Technical Service Bulletin

19 Heating output insufficient (DTC B10D004 and/or B11D501)

19 17 90 2047114/4 September 12, 2017. Supersedes Technical Service Bulletin Group 19 number 17-85 dated April 4, 2017 for reasons listed below.

Figure 1. Washers installed.

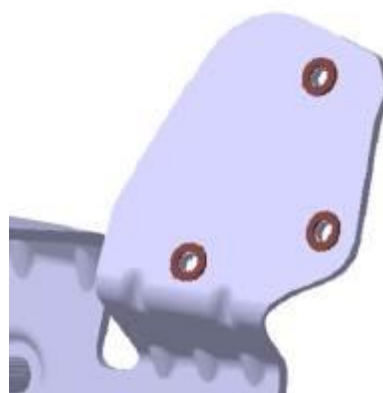
Replace the V50 coolant recirculation pump, use the washers if pump is mounted with screws to the bracket as shown (some models have rubber covered metal band instead):

- N 011 523 21 (3x)

To ensure about 1mm distance between the V50 coolant recirculation pump and its bracket (Figure 1 and 2):
